| EDG RESPONSE | 12 |

ADDRESS
7100 Beacon Ave S
Seattle, WA 981078

PROJECT PROPOSAL
10 Townhome Dwellings
5 Live/work Dwellings
9 Enclosed Parking Stalls
2 Covered Parking Stalls
1 Surface Parking Stall
7 Bicycle Parking

CS2-C Relationship to the Block

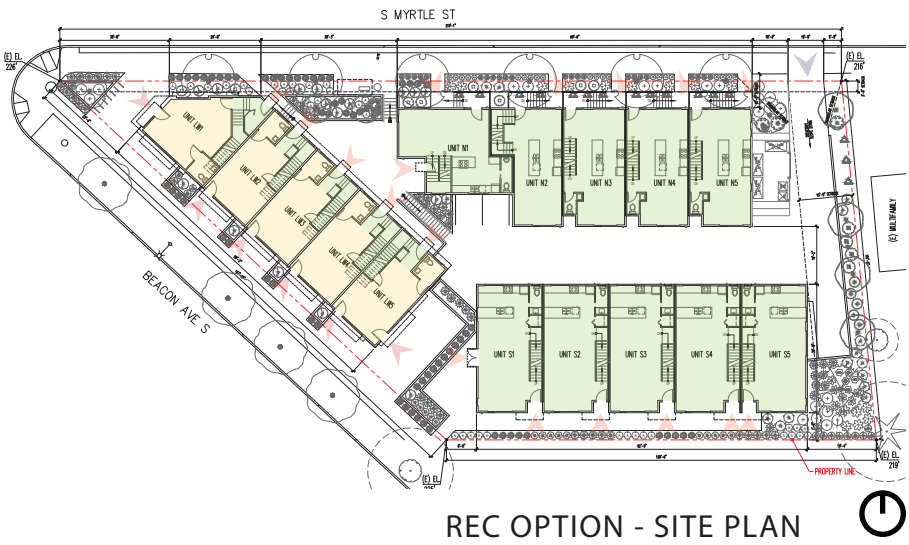
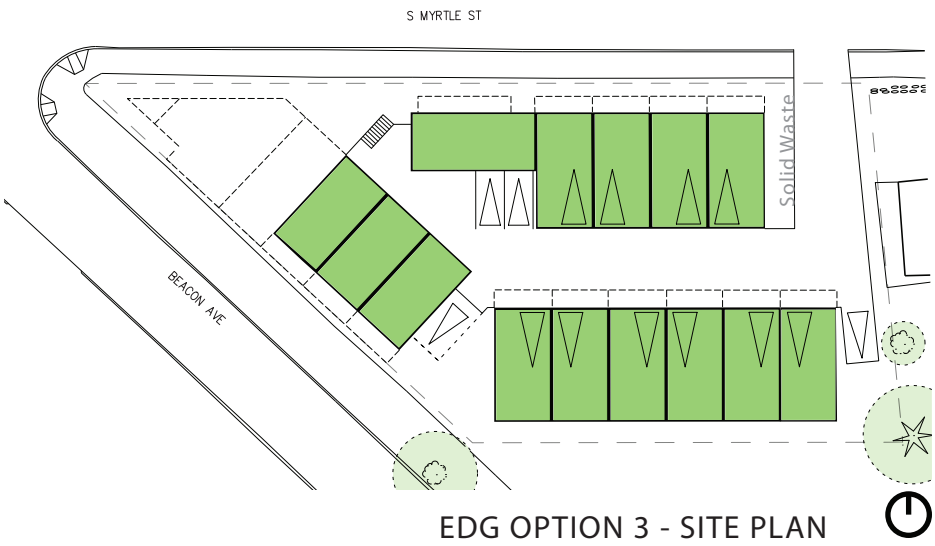
A. The board favored the massing of option 3, due to the potential for pedestrian access to and from the site, siting of the three buildings to the adjacent properties, providing parking internally within the project site, commercial response to Beacon Ave S, and open space locations.

In response to the board’s discussion the project has incorporated the massing of option 3. Pedestrian access to and from the site has been further developed and incorporates internal amenity space, access to the lower internal drive and parking, and privacy for tenants. The amenity space between the live/work building and the north building is situated to correlate with the bus stop along S Myrtle St. A raised planter and grade change separates the public ROW from the private amenity space. This amenity space functions as a front yard while providing residential access to the live/work units and access to the drive aisle below. The amenity space at the SW corner is divided into both commercial and residential amenity spaces. The commercial amenity space is adjacent to live/work unit 5 and is open to Beacon Ave S. The residential amenity space is screened from the public ROW and commercial space via a raised planter. It provides direct access to the adjacent townhomes.

REC OPTION - S MYRTLE ST FACADE

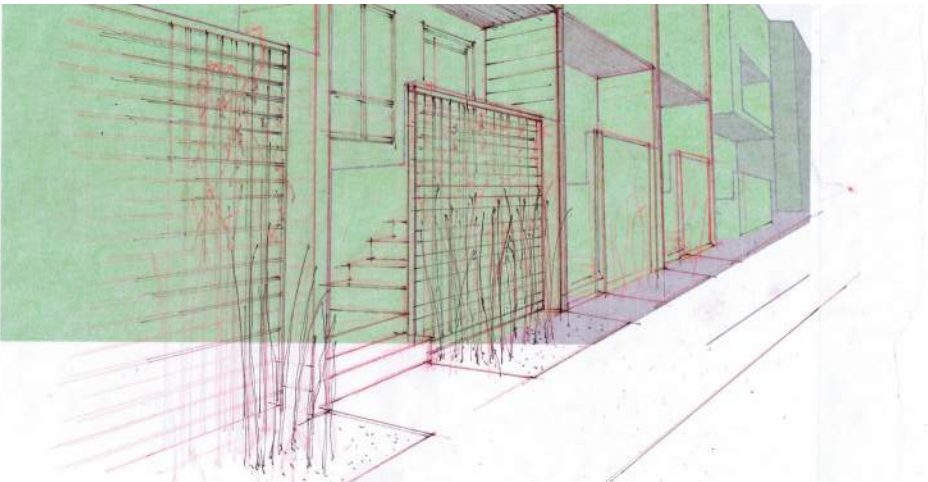
C. The board supported the street-facing facade along S Myrtle St. The board encouraged the applicant to reinforce the residential edge along the street by focusing on the residential entries.

The residential street facing facades have been maintained to provide a good transition to the residential development to the east. To reinforce the residential edge along the street the entries, while setback 10' from the face of the sidewalk, have been lowered. The floor level ranges from 4'-6" at the east unit to 2'-6" at the west unit. The reduction in height provides a stronger connection to the street and public realm while maintaining privacy for tenants via landscaping. Siding materials are wood embossed cementitious board to provide a highly textured material that is residential in nature. Stair guardrails are galvanized metal grating to allow landscaping to extend to the top rail. To further accentuate the residential entries individual doors are painted bright yellow. These cues, along with vertical differentiation between units clearly identify individual dwellings and enforce the structure as residential in nature.
